**Proposal for amendments to UN Regulation No. 43,
document ECE/TRANS/WP.29/GRSG/2015/22 (Safety glazing)**

The aim of this proposal is to specify in details the parameters of the abrasion test machine.

Annex 3, Figure 4, shall be replaced by this diagram with dimensions:

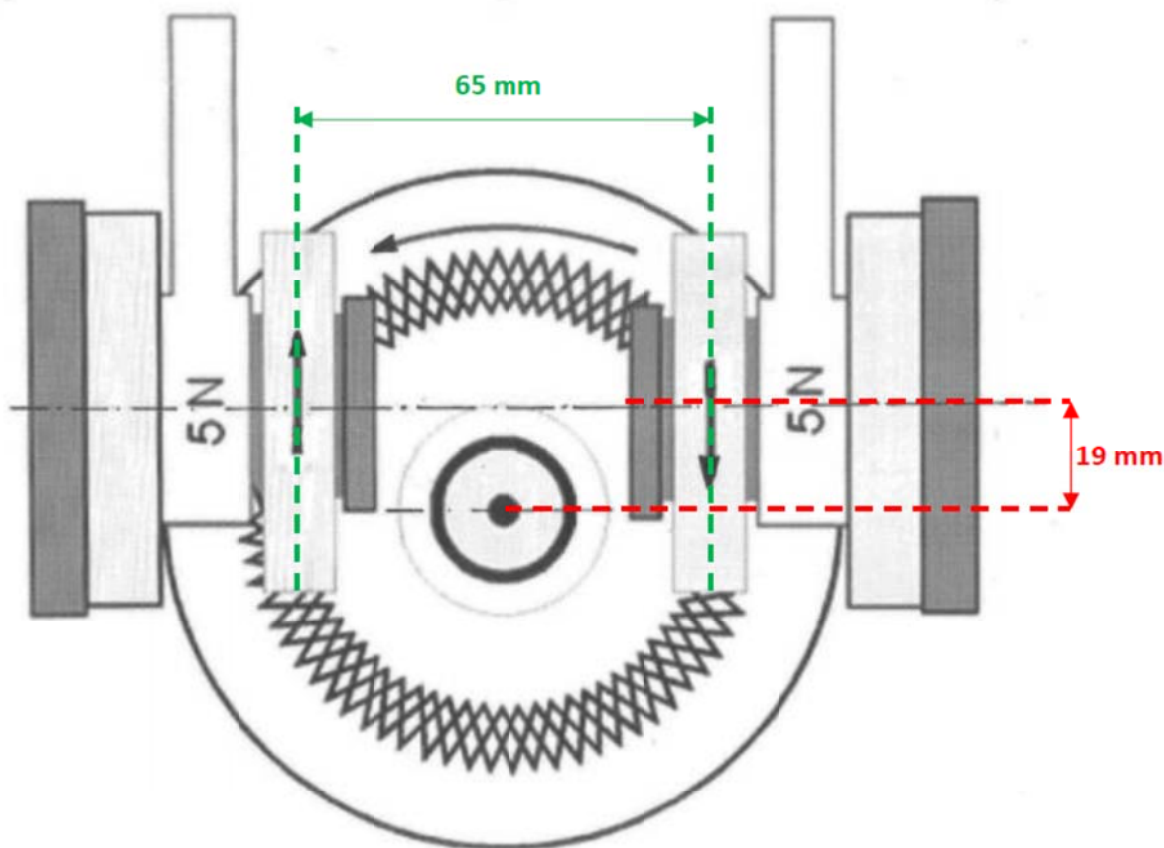
In order to avoid any confusion with reference to the document ECE/TRANS/WP.29/GRSG/2015/22 submitted by Hungary, we propose to replace the diagram of abrading instrument by the diagram that shares the distance clearly between the symmetry planes of the wheels (65 mm) and the offset of the wheel axis from the turntable axis (19 mm) which shall be measured.
